Official Recall Notification U.S. Federal Boat Safety Act - Possible Incorrect Routing of Engine Wire Harness on 5.0L, 350 Mag, and 6.2L

Models Covered	Serial Number Or Year
5.0L, 350 Mag, and 6.2L Non-EC DTS sterndrive engines	2A014073–2A050912

Example of incorrect routing

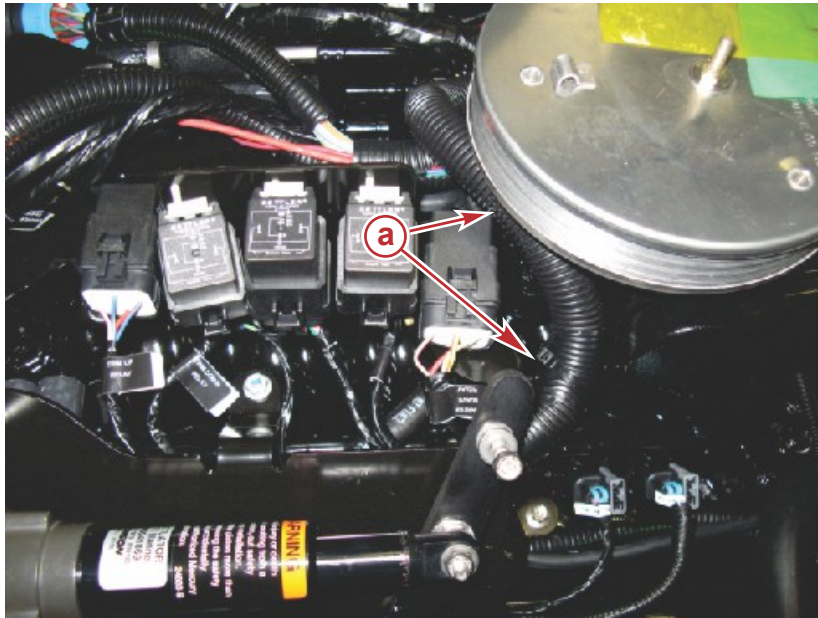
The main engine wire harness may be incorrectly routed too close to the DTS shift actuator. Repeated movement of the DTS shift actuator arm may cause the engine wire harness shielding to wear through, exposing the wires and causing a direct short circuit to ground, which could create an ignition source prior to the fuses interrupting the circuit.

- a - Wire harness routed along the side of the flame arrester
- b - Wire harness not secured to electrical plate, possibly contacting the shift arm

1. Remove the plastic engine flame arrester cover.
2. Inspect the harness for incorrect routing.

Example of the cable tie installed correctly

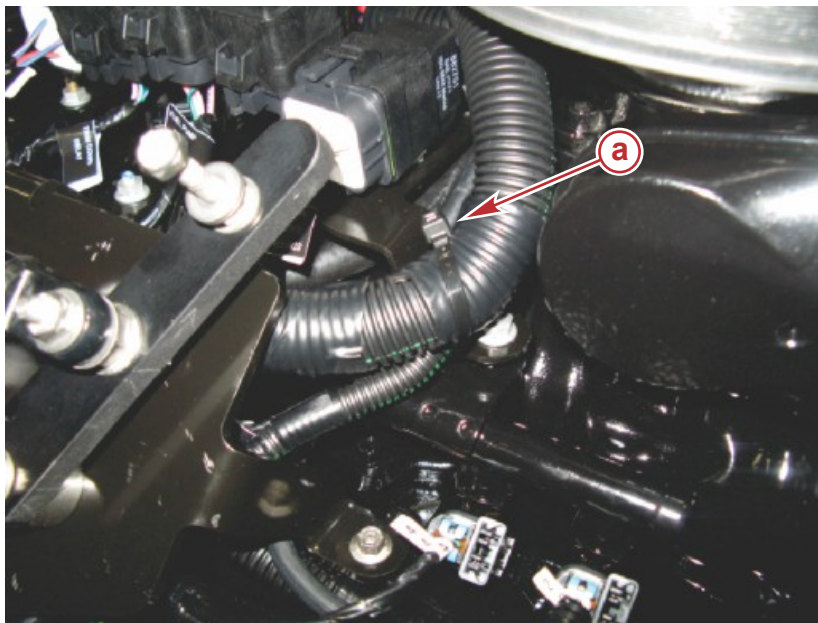
- a** - Secured with cable tie to the foot of the electrical bracket

- a. Verify that the cable tie is installed around the base of the electrical bracket, securing the harness and preventing it from contacting the shift actuator arm.

- b. If the cable tie is not installed, install the cable tie around the harness, securing it to the foot of the electrical plate.
- 4. If the wire harness is routed incorrectly, carefully inspect the harness for damage in the area where the shift actuator arm contacts the harness.
 - a. If damage is present, proceed to step 5
 - b. If no damage is present, proceed to step 7.
- 5. If the harness is chafed or scuffed but the insulation appears intact:
 - a. Securely tape the chafed area with at least two layers of electrical tape.
 - b. Route the wire harness to match the routing of the harness in step 7.

Example of damaged insulation and bare wire

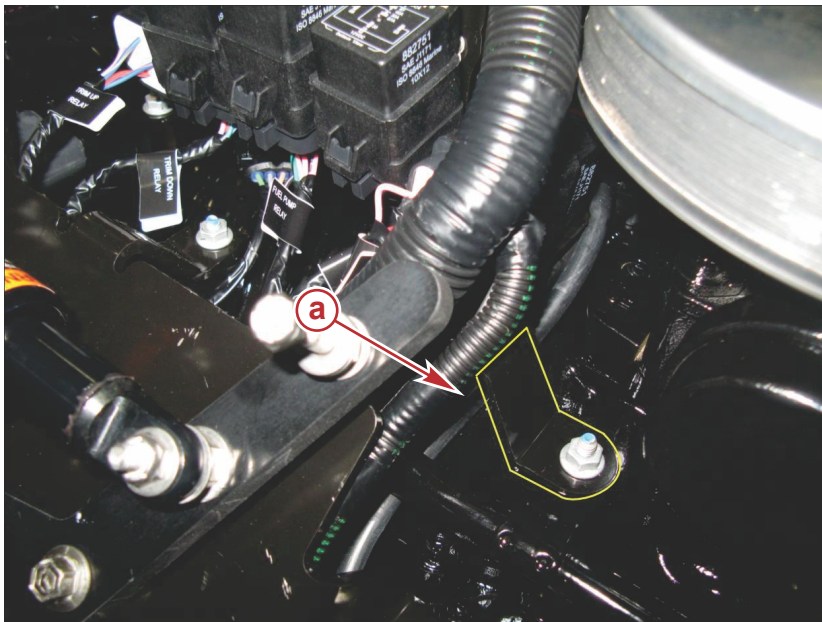
6. If the wire harness was chaffed and the insulation is damaged or revealing the copper wire:

- a. Replace the complete wire harness. Order the part number listed in the Replacement Parts section.
 - b. Route the replacement wire harness to match the routing of the harness in step 7.
7. Correct routing of the harness:
- a. Remove engine flame arrestor
 - b. Secure the harness to the foot of the electrical plate bracket with a cable tie matching the second image in step 3.
